Re: SB25-0009 – Hillcamp Southridge Preliminary Plan – 4th Review Comments

Please see the Applicant Team's comment responses to the fourth submittal comments made on February 11, 2026. The comment responses are in **Blue**.

Sheet 13

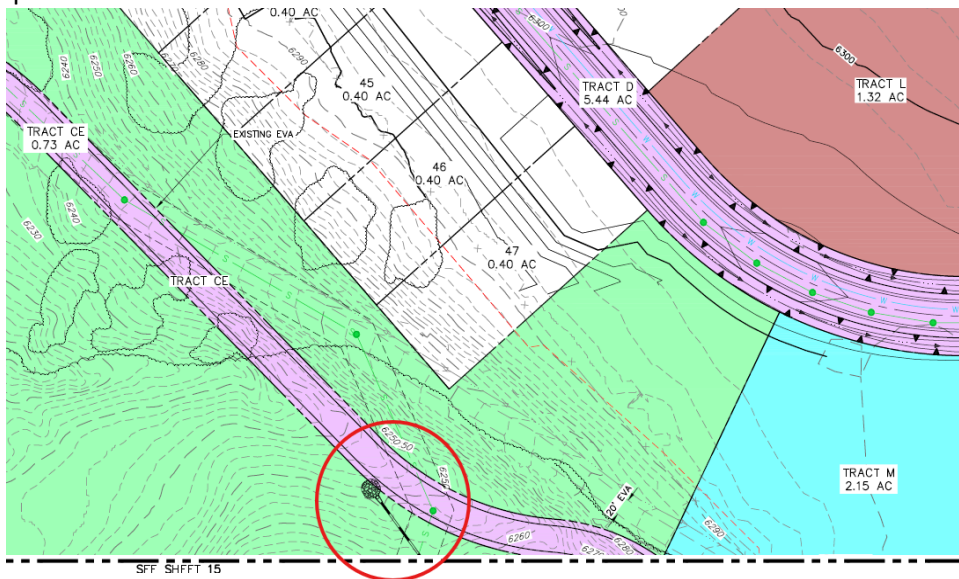
3. **Repeat Comment from November 17, 2025 Technical Review Letter:** Existing gambel oak vegetation stands must be maintained on the back of Lots 37-43 and Lots 27-29, per Section III on Sheet 1 of the SRP PD, Principle 1 in the "Overview" and Guiding Principles section on Sheet 3 of the SRP PD, Section II on Sheet 3 of the SRP PD, and Section III on Sheet 3 of the SRP PD.
 - a. **Additional Comment:** The applicant's response is noted, but to memorialize that response, add a lot development restriction to the portions of these lots (now Lots 40-47 and Lots 18-21 on Sheet 11) that contain existing vegetation and 20% slopes.

Applicant Response: Each lot will be subject to future lot-specific geotechnical investigation to inform the final identification and placement of building envelopes in accordance with the applicable standards and guidelines of the PD. The requirement for these investigations will also

be clearly established within the Development Agreement to consider drainage, slope protection, vegetation preservation, wildfire mitigation, and wildlife movement on all lots.

Sheet 21

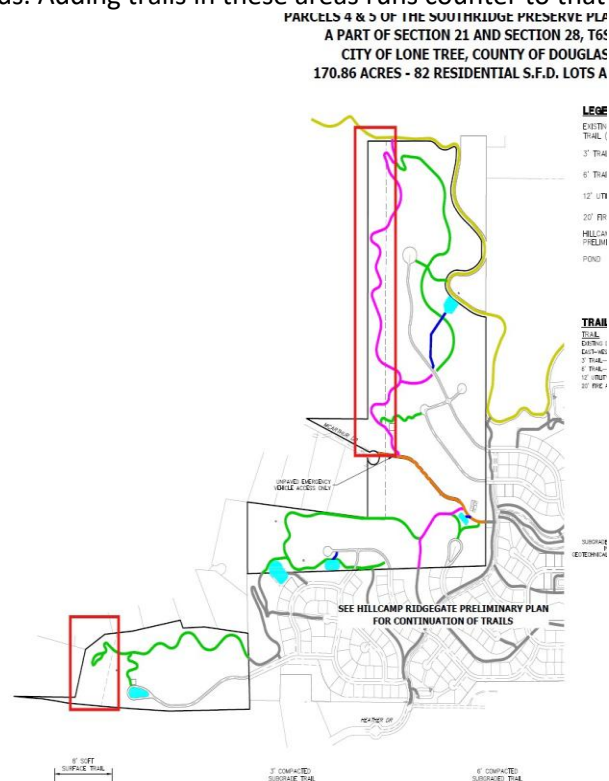
1. All trails must be removed from the Wildlife Movement Corridor and Wildlife Setback Area (see below). The purpose of these setback areas is to protect wildlife habitat from human encroachment for the purpose of preserving existing wildlife populations and associated habitat and vegetation needs. Adding trails in these areas runs counter to that intent.

Applicant Response: Trails have been removed from these areas.
